| | Application No. | Applicant(s) |
|---|--|--|
| Notice of Allowability | 10/680,995 | SPIEGEL, LARRY A. |

EXAMINER'S AMENDMENT

FIG.7

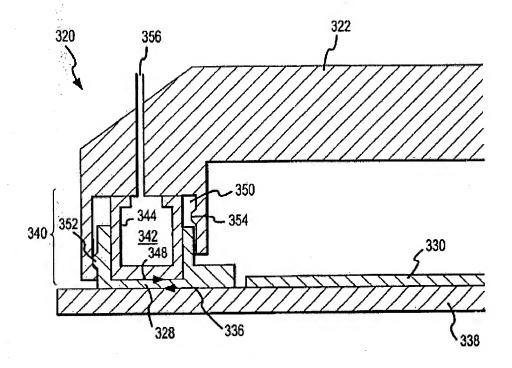
The following is an examiner's statement of reasons for allowance: the specific limitations of "wherein the ridge is sized and dimensioned to impinge upon the inflatable bladder" in the combination as claimed in claim 1 and 10 are not anticipated nor made obvious by the prior art of record. For example, Schultz et al.'6,540,592 discloses in Figure 7 a wafer carrier set forth in the claims. However, ridge 354 does not impinge upon the inflatable bladder 344.

In claim 1, line 14, after "the groove" second occurrence, inserted ", wherein the ridge is sized and dimensioned to impinge upon the inflatable bladder".

In claim 10, line 20, after "the groove" second occurrence, inserted ", wherein the ridge is sized and dimensioned to impinge upon the inflatable bladder".
